**RE: EPA Notice: EIS No.
20170140, Draft, USFS, WY,
North Savery Project**

North Savery DEIS Comments

Objection Reviewing Officer
Rocky Mountain Regional Office
USDA Forest Service
1617 Cole Blvd. Building 17
Lakewood, CO 80401

Appendix A – Display of Draft ROD Selected Actions

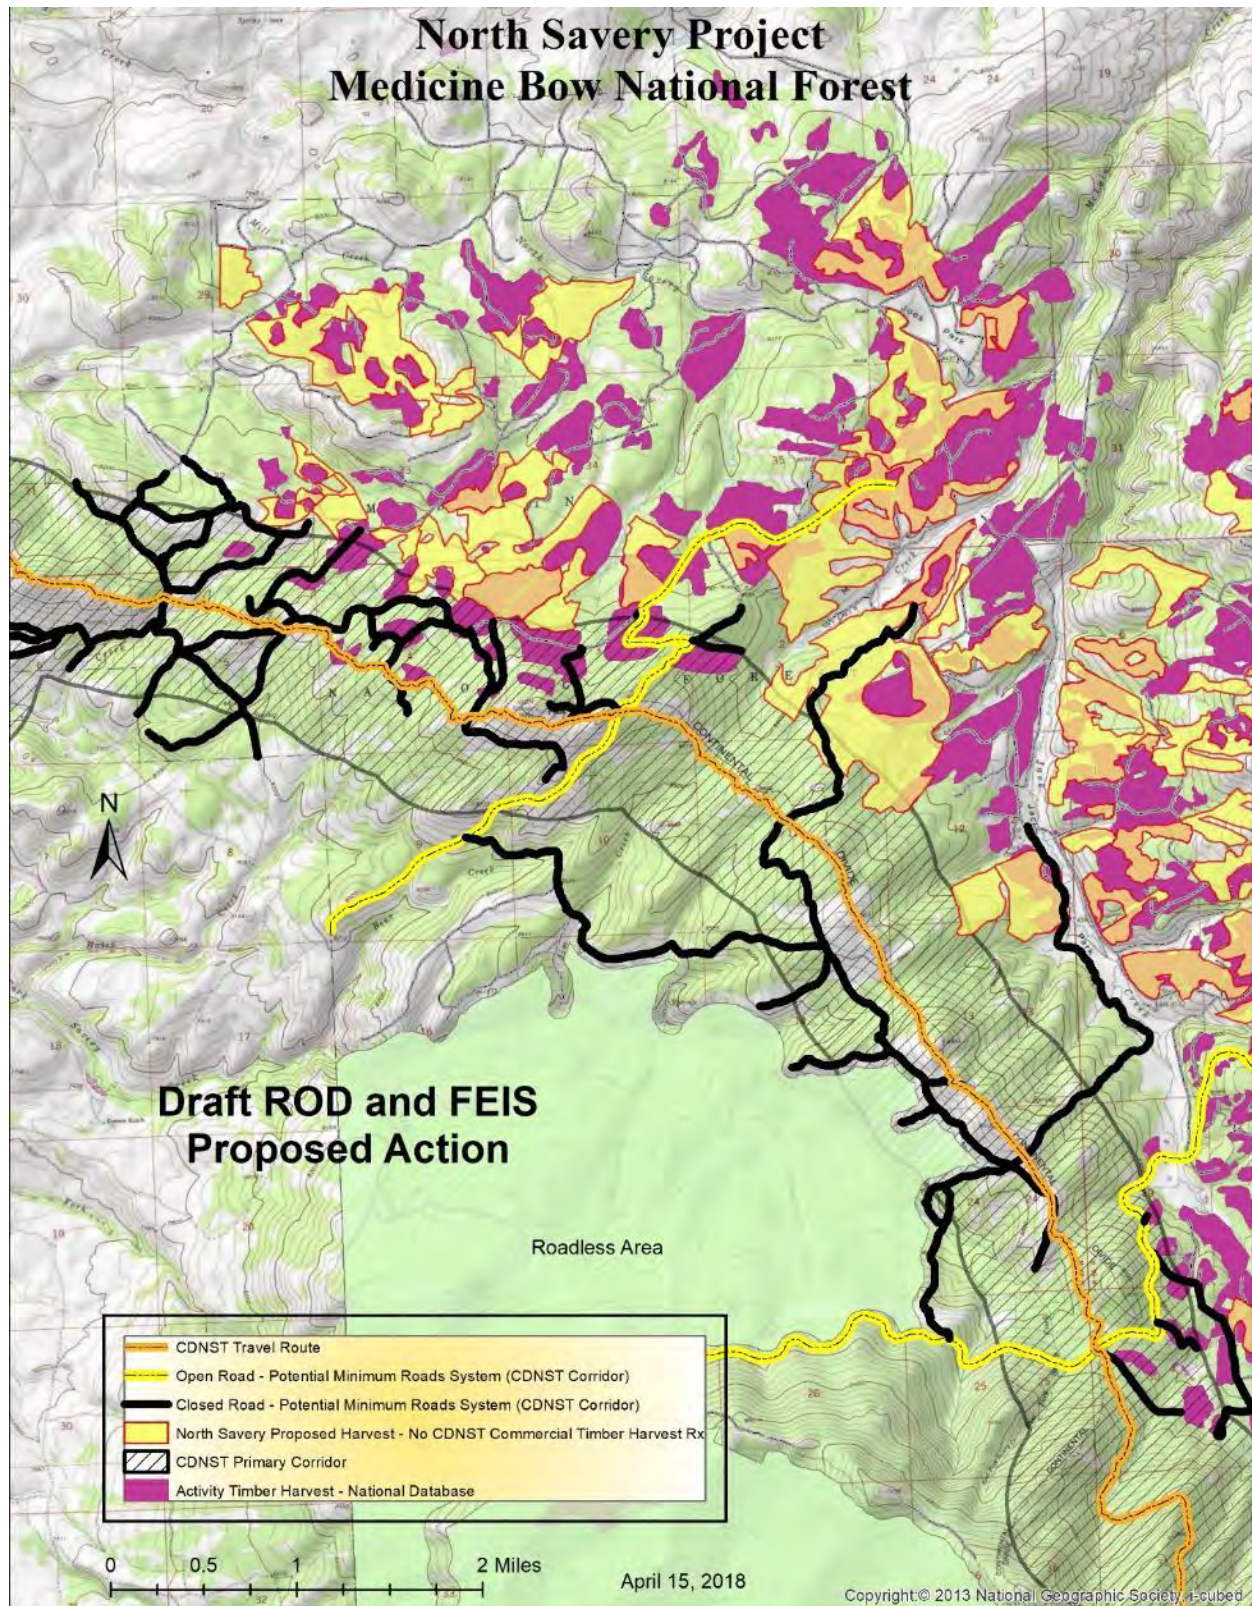
Suggested Remedies to Improve Decision: Remove the following commercial harvest units from the selected action: Divide Peak (numbers 37, 41, 42, 44, 45, 46, 55, and 56) and East Side (number 253).³ This is not intended to preclude the harvesting and removal of hazard trees that may fall on a road, trail, or fence line from these units.

Appendix B – Display of Actions Modifications to address CDNST Scenery, ROS, and Roads Concerns

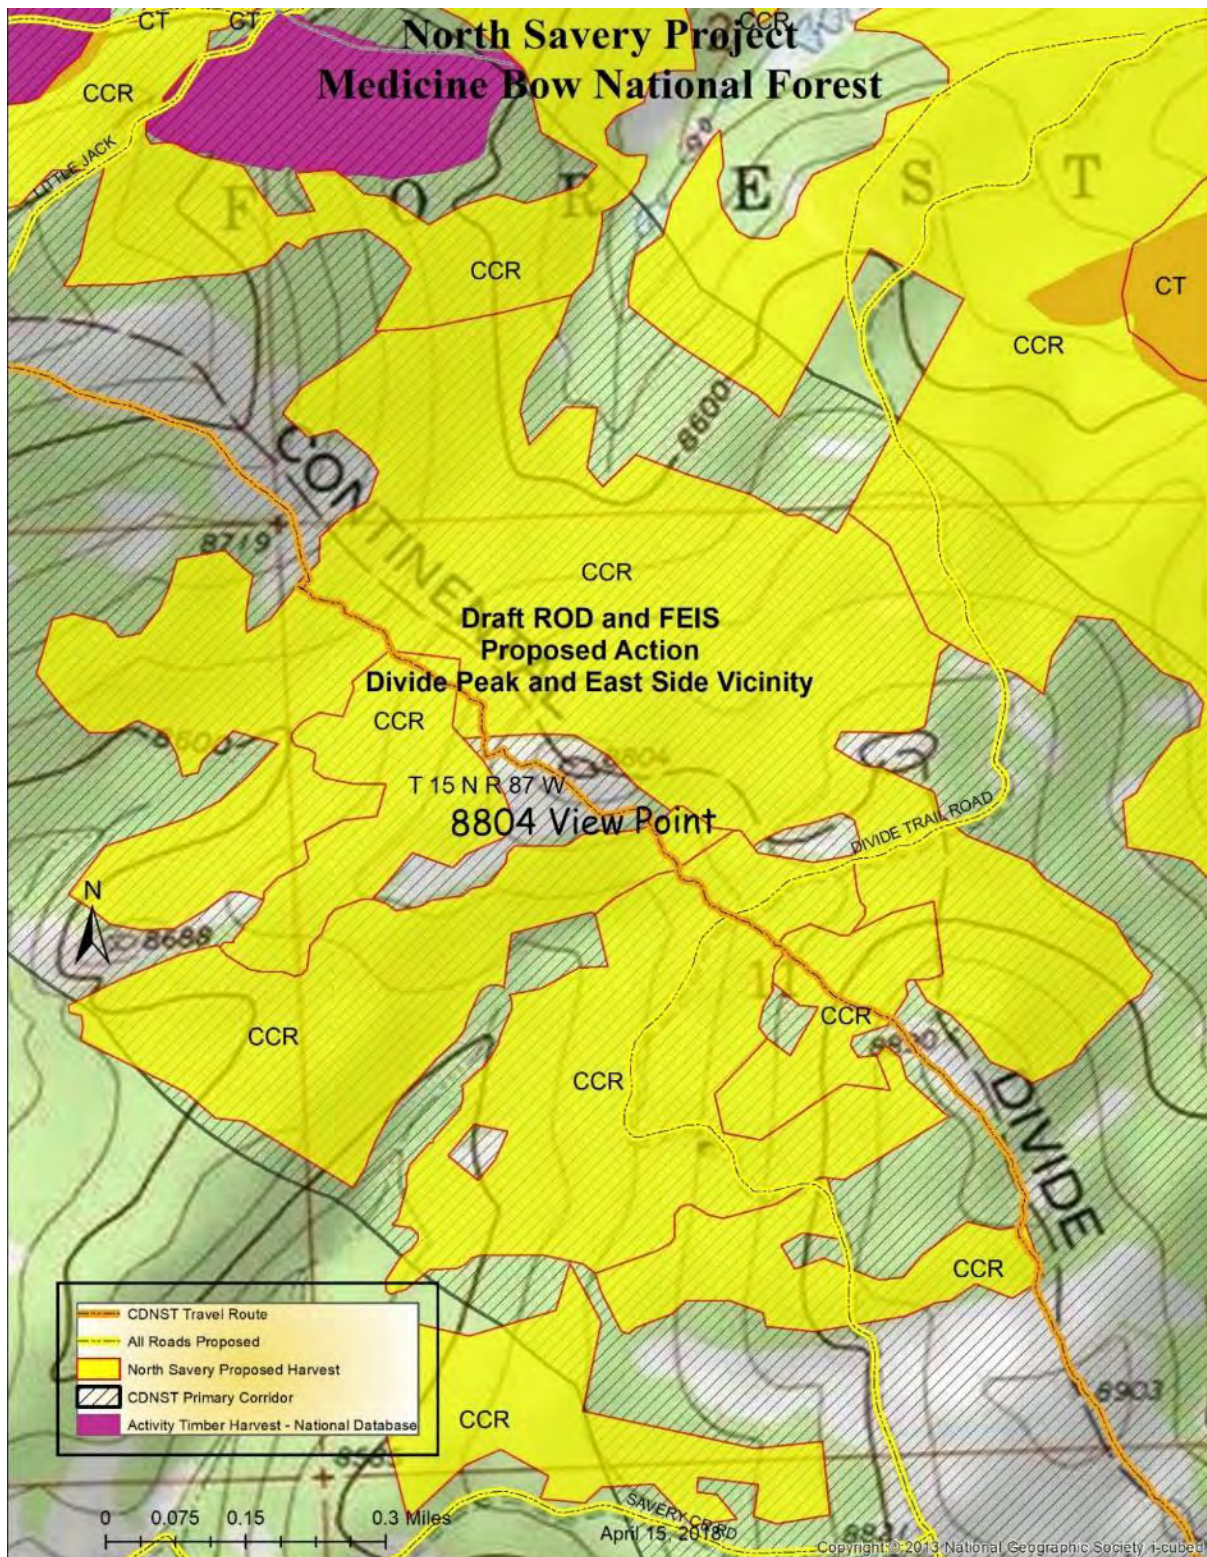
[Issue: To identify a minimum road system, the Forest Plan must be current having addressed changed policies and resource conditions. Relevant to this objection, the 2003 Forest Plan and associated FEIS fail to recognize the direction in the 2009 CDNST Comprehensive Plan. Applying the amended CDNST direction to the identified CDNST corridor would result in fewer roads being designated. A potential minimum road system that reflects CDNST values is depicted on the map in **Appendix B**.
